UNITED STATES  
NUCLEAR REGULATORY COMMISSION  
OFFICE OF NUCLEAR REACTOR REGULATION  
WASHINGTON, D.C. 20555

November 6, 1992

NRC INFORMATION NOTICE 92-61, SUPPLEMENT 1: LOSS OF HIGH HEAD  
SAFETY INJECTION

FIGURE 1  
EXISTING SHEARON HARRIS HIGH HEAD INJECTION SYSTEM

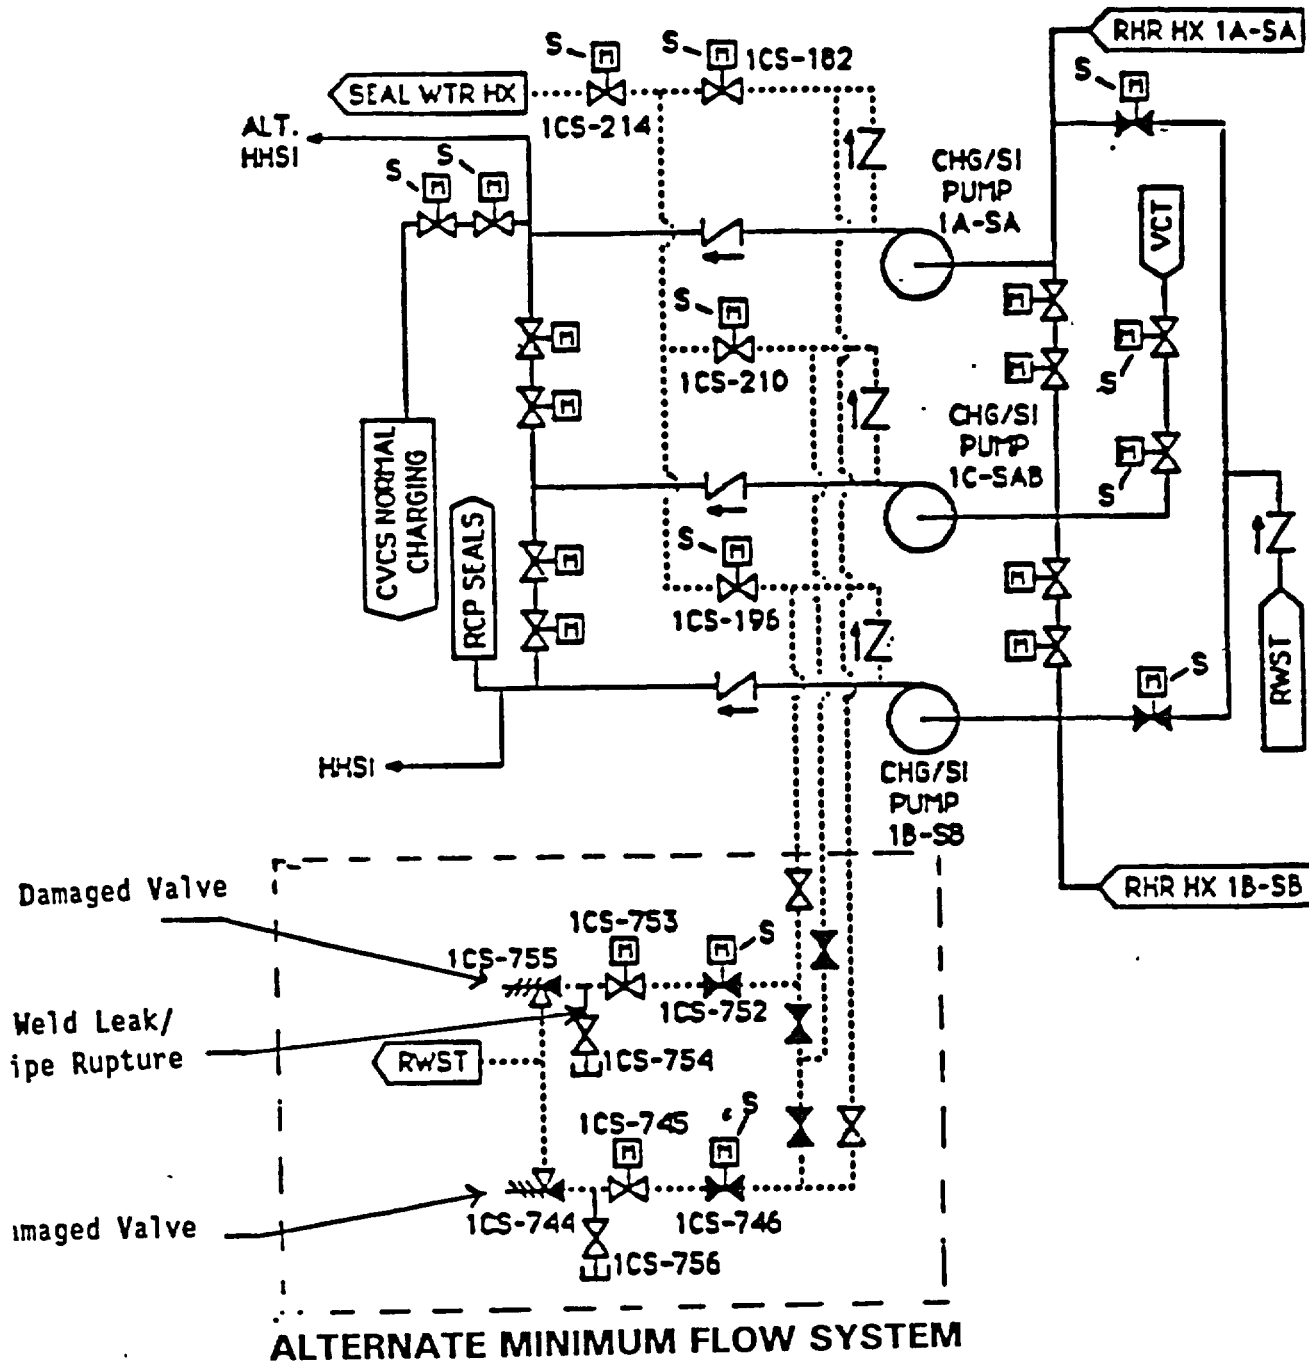
On April 3, 1991, Carolina Power & Light Company (the licensee) determined that the HHSI system for the Shearon Harris Nuclear Power Plant had been in a degraded condition during the previous operating cycle. The degraded condition resulted from relief valve and drain line failures in the AMF system for the charging/safety injection pumps (CSIPs) which would have diverted a significant amount of safety injection (SI) flow away from the reactor coolant system (RCS). Additional description of the existing AMF system and additional discussion regarding the specifics of this event are contained in Information Notice 92-61, "Loss of High Head Safety Injection," dated August 20, 1992, and in NRC Special Inspection Report 50-400/92-201, dated September 1, 1992. In addition, Figure 1 provides a schematic of the existing HHSI system at Shearon Harris.

On September 17, 1992, the licensee tested the HHSI AMF system. When the 1CS-746 motor-operated isolation valve was opened to test train "A" of the HHSI AMF system (1CS-746 will stroke fully open in approximately 7 seconds), relief valve 1CS-744 chattered slightly for several seconds and then

successfully opened. When the ICS-752 motor-operated isolation valve was opened (also requiring approximately 7 seconds) to test train "B" of the HHSI AMF system, relief valve ICS-755 chattered significantly, the valve bellows failed, and the test was halted. Additional discussion regarding these tests is contained in NRC Inspection Report 50-400/92-17, dated October 1, 1992.

The licensee has indicated that the chattering of the ICS-755 relief valve is believed to have been caused by hydraulic effects associated with opening the ICS-752 motor-operated isolation valve. The NRC staff believes that the fluid frictional and dynamic pressure loss characteristics of the long inlet piping upstream of ICS-752 may have also contributed to the chattering. The licensee indicated that the testing, disassembly, and examination of the ICS-755 relief valve identified that the valve lift setpoint (2300 psi) had not changed, and that the bellows failure was caused by cyclic fatigue of an inside weld. Static testing to verify the valve lift setpoint had been routinely performed, during the plant lifetime, whereas testing to simulate flow through the valve to assure proper operation and reseating apparently never was performed.

The Crosby relief valve technical manual states that chattering can affect the life, operation, and performance of a relief valve. The manual recommends that relief valves not have restricted inlets because restricted inlets can cause valve chatter. The opening and closing of the motor-operated isolation valve in the existing HHSI AMF design at Shearon Harris restricts the inlet to the relief valve. In addition, relief valves are generally designed to provide system overpressure protection and are not designed for continuous fluid throttling purposes.

FIGURE 2  
MODIFIED SHEARON HARRIS HIGH HEAD INJECTION SYSTEM

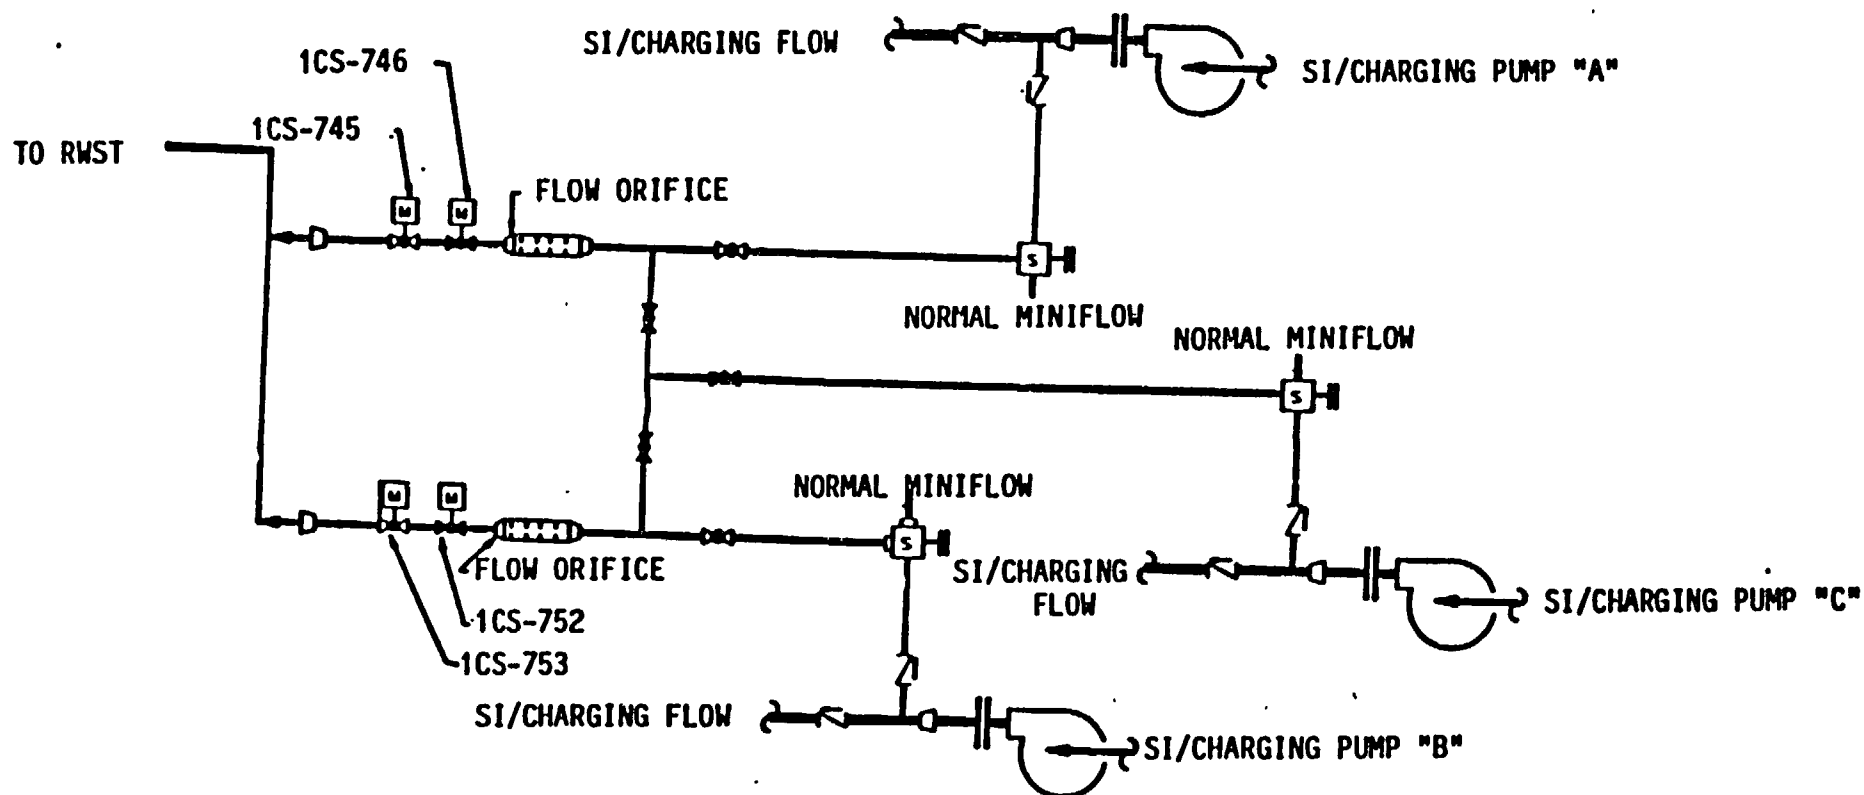
The licensee also indicated that modifications will be made to the HHSI AMF system before restarting the plant from the current refueling outage. Figure 2 provides a schematic of the proposed modifications to the HHSI AMF system at Shearon Harris. The licensee intends to install flow restricting orifices upstream of the motor-operated isolation valves and to remove the relief valves. The motor-operated isolation valve actuation logic will also be modified so that the isolation valves will open when a safety injection signal is present coincident with RCS pressure above approximately 2300 psi.
